**NOTICE OF PROPOSED AMENDMENT (NPA) No 16/2004
DRAFT DECISION OF THE EXECUTIVE DIRECTOR OF THE AGENCY,
on certification specifications for large aeroplanes (CS-25)**

Flight in Icing Conditions

2. The purpose of this Notice of Proposed Amendment (NPA) is to propose changes to the certifications specifications for large aeroplanes (CS-25), related to performance and handling characteristics in icing conditions. The reason for this proposal is outlined further below. This measure is included in the Agency's 2004 rulemaking programme.

Relationship of Proposed JAR 25.21(g)(1) and (2) to other Proposals, including JAR 25.143(j) and 25.207(h)

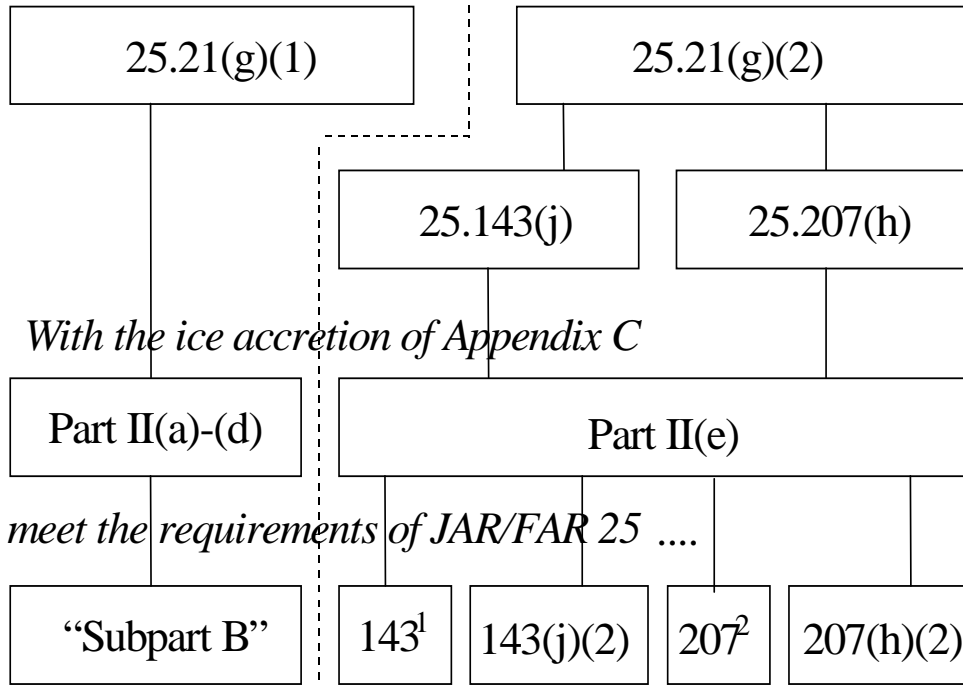
The FTHWG Report also includes extensive advisory material, which is presented in this NPA as a proposed new ACJ to 25.21(g). This AMC provides acceptable means of compliance for the performance and handling requirements of Subpart B. It also gives advice on other matters pertinent to approval for flight in icing conditions such as:

- Consideration of systems aspects and failure conditions,
- Flight testing and analysis methods, and
- The development of the ice accretions appropriate to various flight phases
